Mona Change Request Report

Application Reference: EN010137 Document Reference: S_CR_2 Document Number: MOCNS-J3303-BGS-10410 15 November 2024 F02

Extract from Works Plans – Onshore (AS-003)

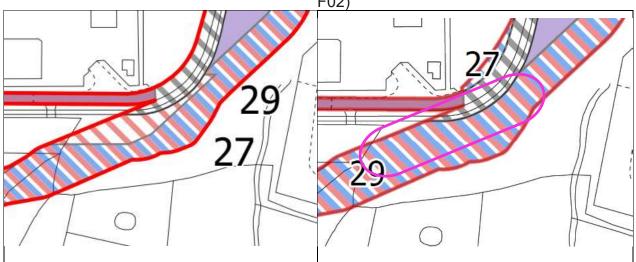
Change 2b – Amendment to Work No. 27 to widen the temporary onshore substation construction access road at grid reference SJ 01906 735519 by including a small area of additional land to the area identified for Work No. 27 (approximately 538m²) within the existing Order Limits. This land is currently identified as part of the permanent onshore substation access (Work No. 29) only.

1.2.2.4 The Applicant's preliminary design work has identified additional space is needed along the temporary construction access road in this area to facilitate the AIL's whilst ensuring adequate space for the fencing requirements outlined in the Outline Fencing Management Plan (REP2-048).

Extract from Works Plans – Onshore (AS-003) Extract from Change Request: Works Plan -Onshore (Document Reference S_CR_4

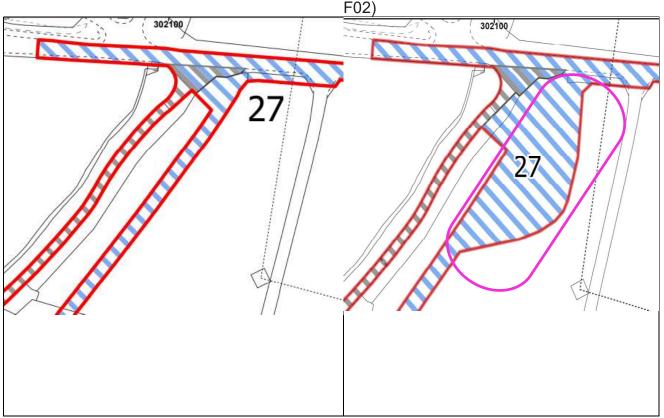
1.2.3 Change 3 – Amendment of the proposed Order Limits to include additional land adjacent to the onshore substation construction access bellmouth to accommodate a temporary construction drainage attenuation basin

- 1.2.3.1 This change results in a widened temporary onshore substation construction access road (eastward) to accommodate an additional temporary Sustainable Urban Drainage System (SuDS) attenuation pond at the northern extent of the onshore substation construction access road.

- 1.2.3.2 The additional area of land required for Change 3 amounts to approximately 2350m². Whilst this land was included within the Mona PEIR Offshore Wind Project Boundary published in April 2023, it was not included upon submission on the basis of the preliminary designs for the onshore substation construction access road. However, the Applicant's early detailed design works for the onshore substation construction access road, including the swept path analysis outlined in Change 2 (specifically Change 2a), have identified the need for additional land take. This is in order to deliver attenuation to control the discharge of surface water during construction, in part due to the wider road outlined in Change 2a, and also from the requirement for great crested newt fencing to be deployed, likely resulting in additional drainage pathways. It is proposed to construct a temporary SuDS attenuation basin as a measure to control this additional surface water runoff. The proposed Change 3 will result in

Figure 3: Dimensions of 4x4 with trailer.

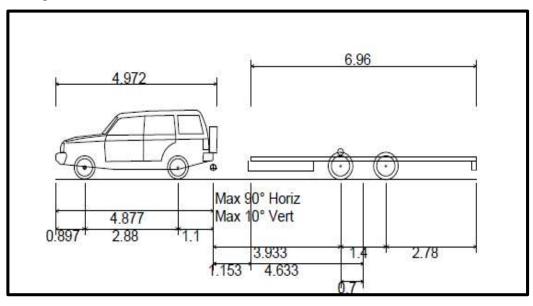
- 1.3.1.1 It is proposed that Change Request Access AC-T1 will only be used for onshore site preparation works which include archaeological investigations, investigations for the purpose of assessing ground conditions (to establish the detailed design of the finished ground level and onshore substation platform), ecological surveys and site clearance (surveys and tree and vegetation removal). It is likely that this access will be used intermittently over a period of approximately 12 months.
- 1.3.1.2 The largest type of vehicle that would utilise Change Request Access AC-T1 for the duration of the site preparation works are light vehicles, vans or 4x4 vehicles

with relevant machinery being carried on trailers. An example vehicle is shown on Figure 3 below.

Figure 4: Visibility splays at existing access junction to the site

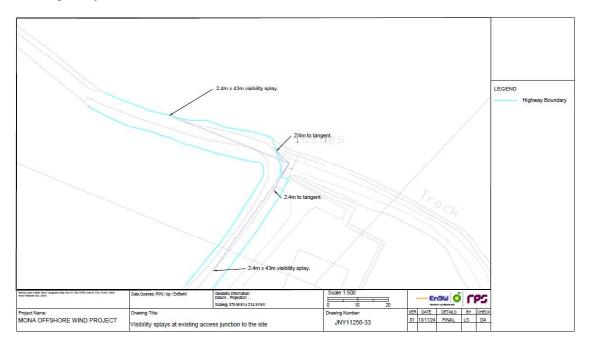
- 1.3.2.1 The posted speed limit along the Cefn road is the NSL of 60 mph, however due to its geometries and alignment vehicle speeds can be expected to not exceed 30 mph.
- 1.3.2.2 The requisite visibility splay requirements of 2.4 m x 43 m for 30 mph vehicle speeds in line with guidance set out in Manual for Streets 2 (The Chartered Institute of Highways and Transportation, 2010) are achievable in both directions from the Junction. These visibility splays are shown on Figure 4.
- 1.3.2.3 A swept path analysis of a 4x4 and trailer accessing and egressing Change Request Access AC-T1 to and from the west (i.e. to and from the B5381 Glascoed Road) at Figure 4 and shows vehicles accessing and egressing

Change Request Access AC-T1 satisfactorily with no overrun of the edge of the carriageway.

Figure 5: Swept path analysis of 4x4 and trailer from B5381 to Change Request Access AC-T1

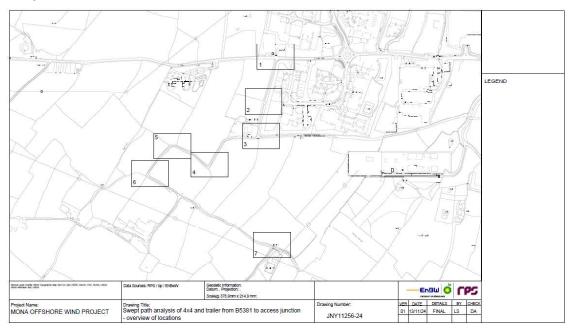
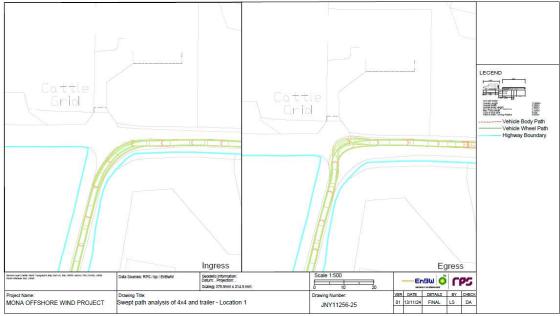
1.2.2.4 Swept path analyses of a 4x4 and trailer travelling along the Cefn road between the Cefn road and Change Request Access AC-T1 are shown on Figure 5 at the end of this technical note and show no overrunning of the edge of carriageway.

Swept path analyses have shown these travelling between the B5381 Glascoed Road and Change Request Access AC-T1 satisfactorily with no overrun of the edge of carriageway.
